Products affected

Change of plastic material from PET to PA6 (Socket) Inclusion of configuration code on label

Product Change Notification					PCN KEA-Print			
owner	creation date	release date	released by	change order no	rev	page	D40 047 426	
bachmajo	10.07.2017	13.09.2017	buerglal	2013177	Α	1 of 2	D10-017-136

3 Detail description of change

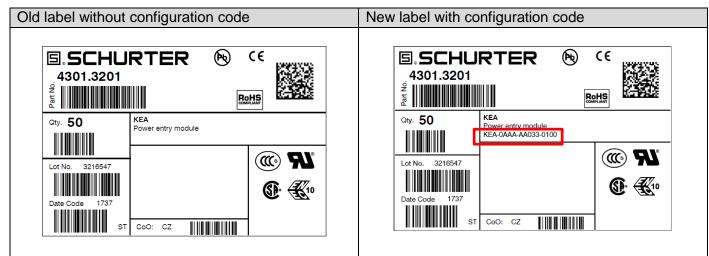
- Product improvement to fulfil the enhanced glow wire requirements according to the updated standard IEC 60127-6 and the standard IEC 60335-1 for appliances in unattended use.
- Recertification by VDE
- Recertification by UL

Form Yes Change of plastic material only No change for dimension Fit No **Function** No No function change Manufacturing No No change for manufacturing site Label Yes Configuration Code indicated on label
